## Product Change Notification / CENO-13NWUA734

CCB 6079 Initial Notice: Qualification of MTAI as an additional assembly site for selected AT24C512C-SSHxx, AT24CM01-SSHxx and AT24CM02-SSHxx device families available in 8L SOIC (3.90mm(.150in)) package.

**PCN #: CENO-13NWUA734**

**CCB 6079**  
**Pre and Post Change Summary**  
**PCN #: CENO-13NWUA734**

## ANAP

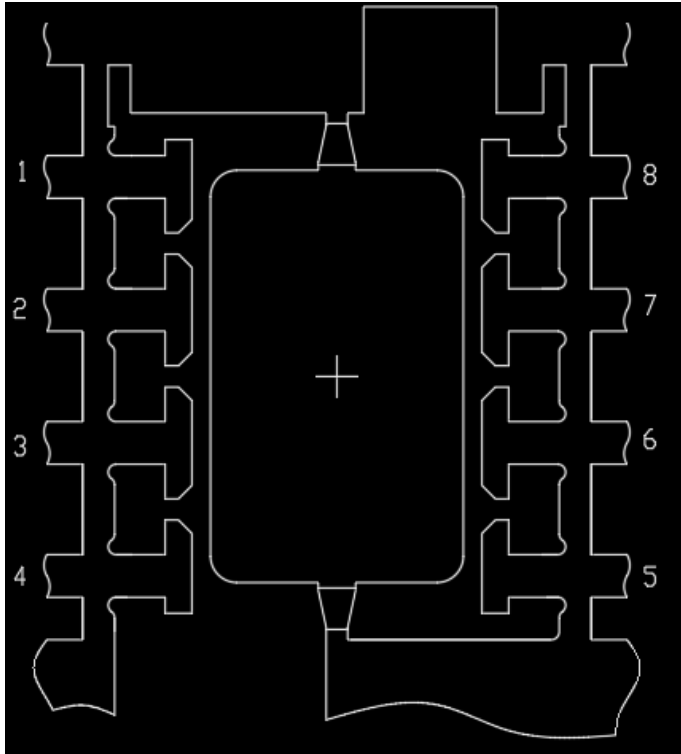
Lead frame Material	C194
Lead-Frame Paddle Size	95 x 155 mils
Lead Plating	NiPdAu
Wire Material	PdCu

## ASSH

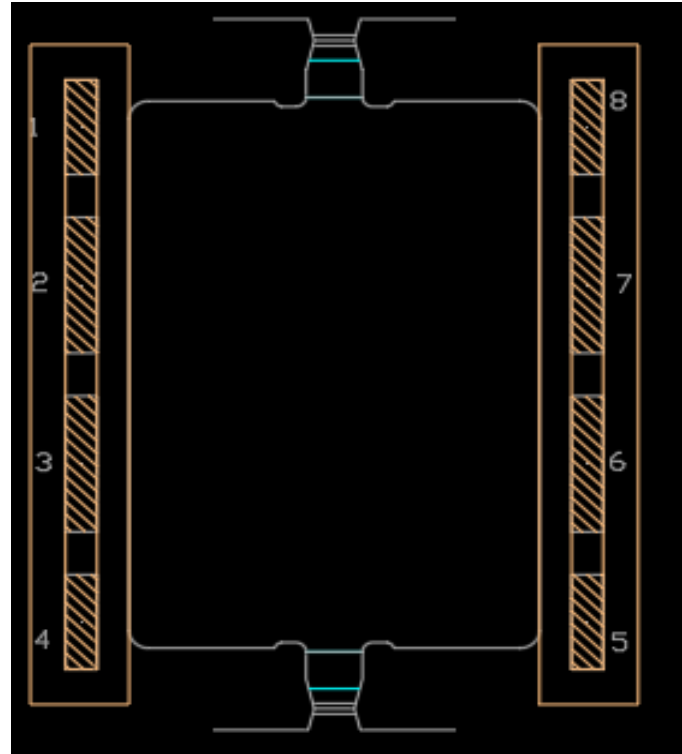
Lead frame Material	C194
Lead-Frame Paddle Size	102 x 153 mils
Lead Plating	Matte tin
Wire Material	CuPdAu

## MTAI

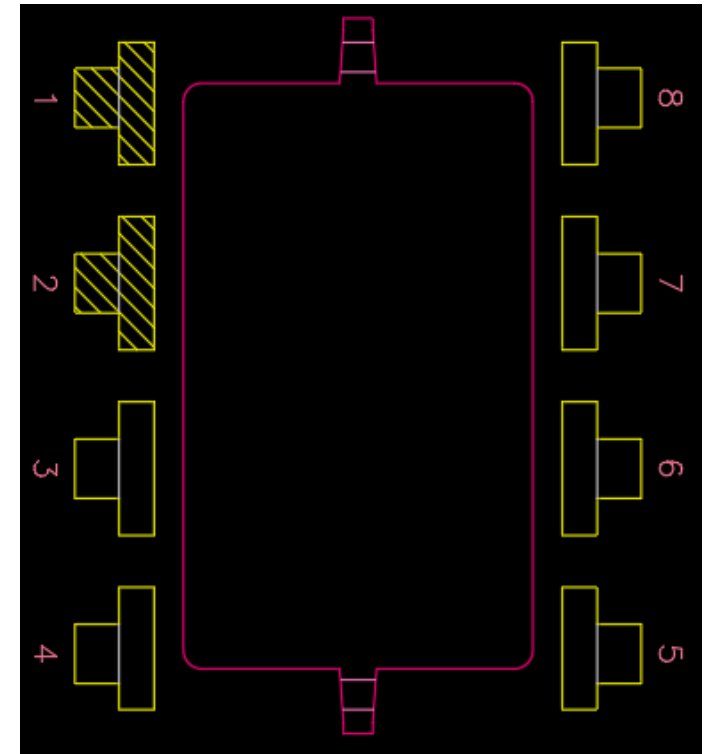
Lead frame Material	C194
Lead-Frame Paddle Size	95 x 158 mils
Lead Plating	Matte tin
Wire Material	CuPdAu
